M-9A0 (Calpella + N11P/M Discrete Graphic)

FOXCONN		HON HAI Precision Ind. Co., Ltd.	
Title		CCPBG - R&D Division	
Size		Document Number	
Custom		M9A0 MP	
Date:		Wednesday, October 28, 2009	Sheet 5 of 73
		Rev 1.1

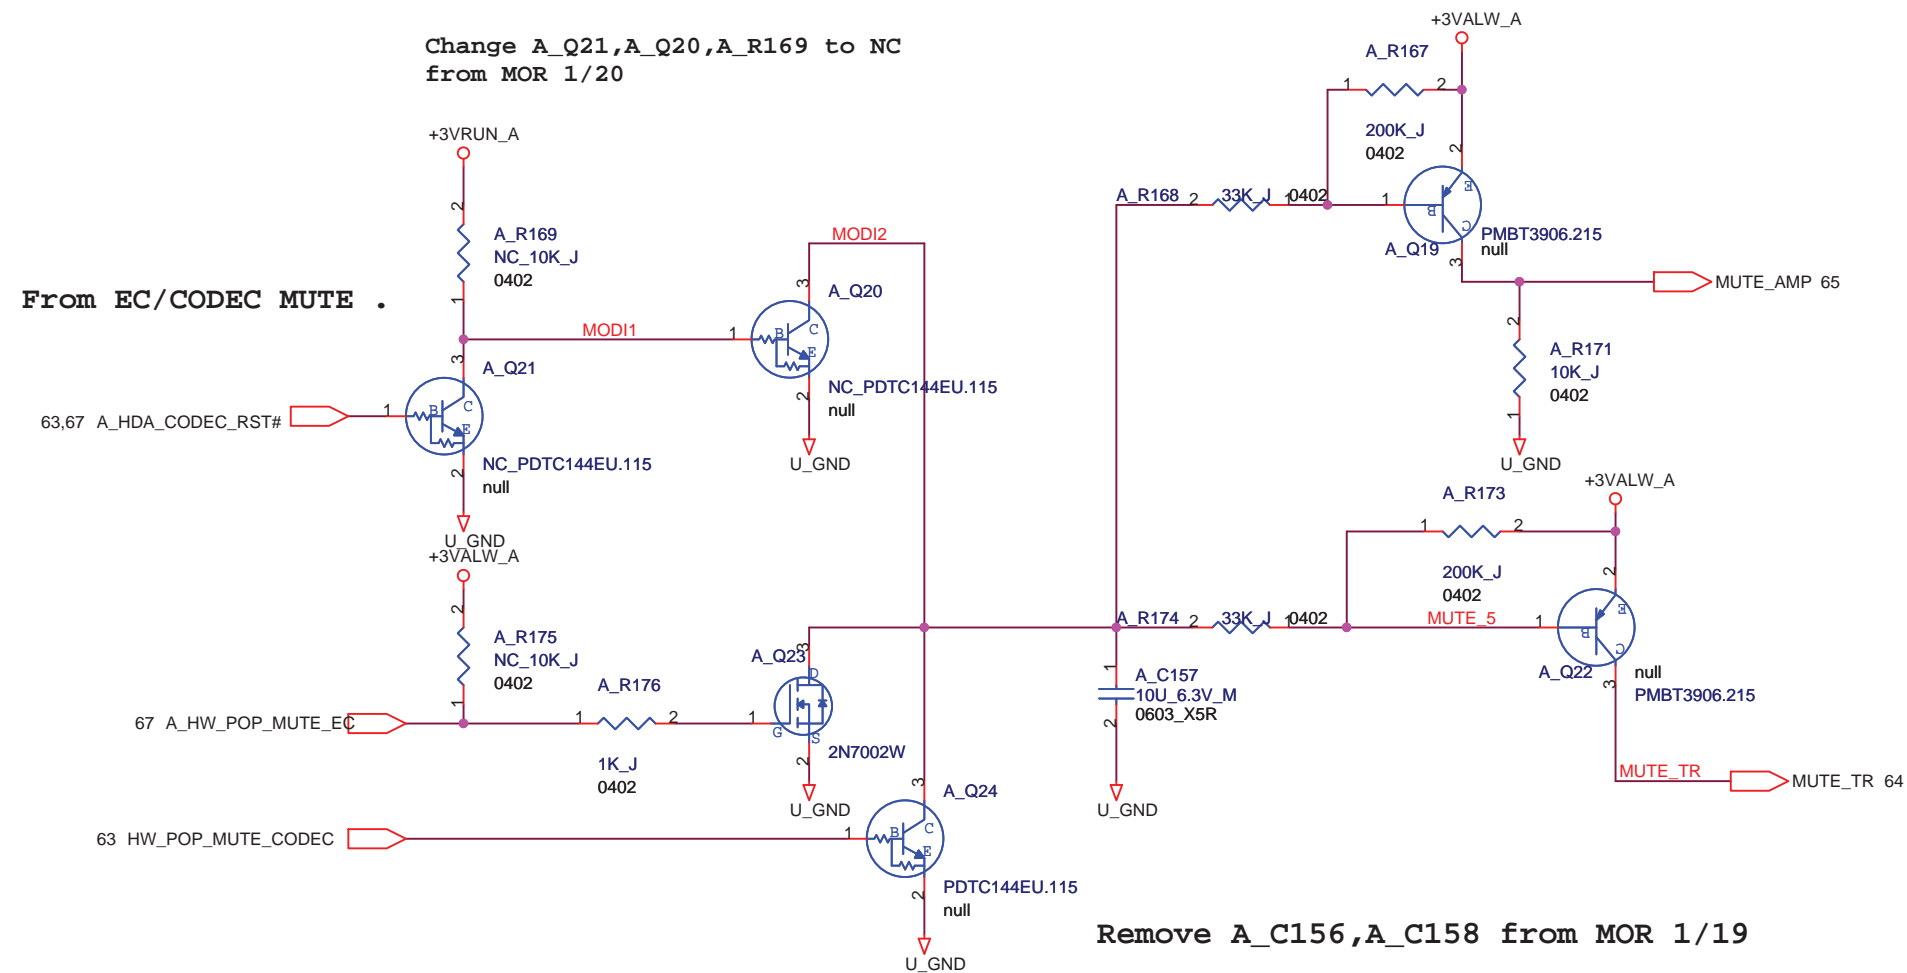
For Mor request, add the speaker cable short protection circuit
